## Re: CPUC Concurrence with PG&E Minor Project Refinement 4 for the Manning 500/230 kV Substation Project

## Manning 500/230 Kilovolt Substation Project CPUC Minor Project Refinement (MPR) Form

<b>Date Requested: May 1, 2026</b>				
<b>Report No.:</b> 4		<b>Approval Agency:</b> California Public Utilities Commission (CPUC)		
<b>Property Owner(s):</b> LS Power Grid California, LLC		<b>Location/Milepost:</b> PG&E Telecommunication Yard outside Manning Substation		
<b>Land Use/Vegetative Cover:</b> Disturbed		<b>Sensitive Resources:</b> Aesthetics Biological Resources Cultural and Tribal Cultural Resources Geology and Soils Hydrology and Water Quality Noise and Vibration		
<b>Modification From:</b>	<input type="checkbox"/> Permit	<input type="checkbox"/> Plan/Procedure	<input type="checkbox"/> Specification	<input type="checkbox"/> Drawing
	<input type="checkbox"/> Mitigation Measure	<input checked="" type="checkbox"/> Other: PG&E Telecommunications Yard Design

Figure 2-4, referenced in the above excerpt, shows the PG&E Communication Yard located just outside the security wall of Manning Substation but does not show any paved access roads within it.

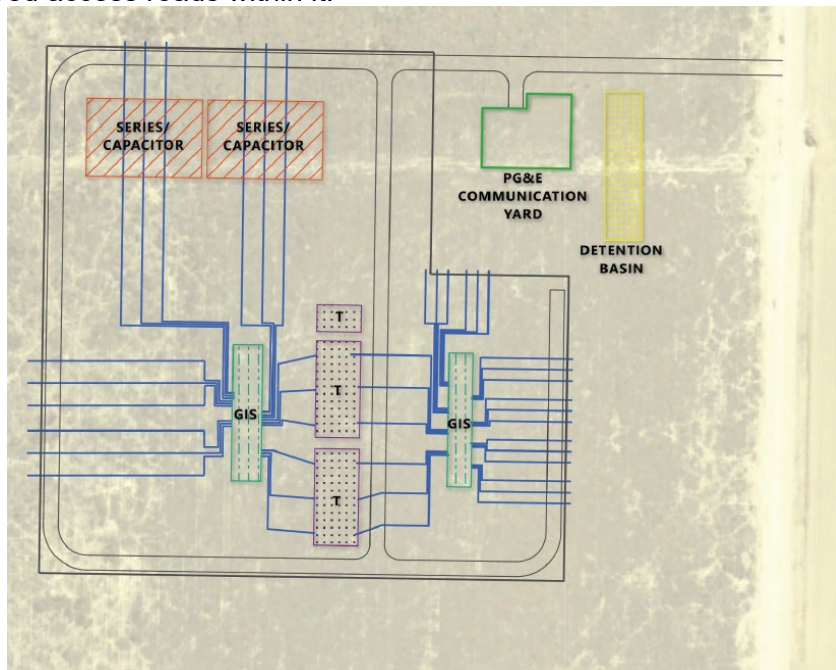
While Figure 2-4 from the Final IS/MND does not identify this road within the PG&E Telecommunications Yard, the description of paved roadways from Section 3.10.4(b) accurately reflects the general scope. The inclusion of 0.03 acres of paved road within the PG&E Telecommunications Yard will not substantially alter the estimated paved area of 14 acres as described in the CEQA document.

PG&E will be paving an access road within the PG&E Telecommunications Yard. This access road will be approximately 20 feet by 74 feet in area (1480 square feet, 0.03 acres).

PG&E’s paved access road within the PG&E Communication Yard will be in the following approximate location:

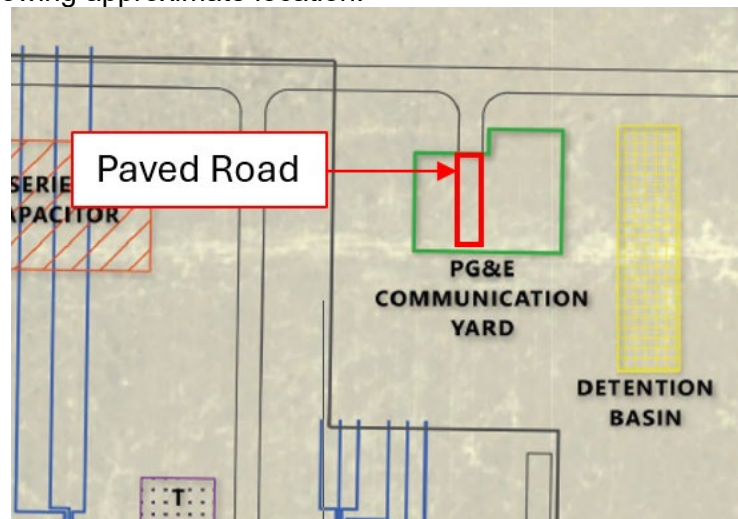
“Lighting will be installed and will conform to the National Electric Safety Code requirements and other applicable outdoor lighting codes. The facility will not require 24-hour illumination.”

PG&E’s Telecommunications Yard will have 24-hour illumination to ensure a safe working environment for crews, particularly at access control points, and in front of panel doors and equipment cabinets.

Consistent with the IES recommendations for exterior utility and industrial facilities, lighting will provide a minimum illumination level of approximately 0.2 footcandle across general site areas and approximately 2.0 footcandles at access points and areas where personnel are required to operate or service equipment, such as equipment cabinets. 0.2 footcandle looks like a dimly lit outdoor area at night, similar to a neighborhood street far from a direct streetlamp or a parking lot in its darkest corners. Two footcandles is enough light to see general shapes and avoid obstacles but still too dark to read writing and fine detail is difficult to distinguish.

Site lighting will be limited to the minimum necessary to ensure safe access and operations and will be directed downward and shielded as appropriate to minimize glare and light spill beyond the facility. This level of illumination is sufficient for wayfinding and safety while avoiding excessive brightness, glare, or over-illumination.
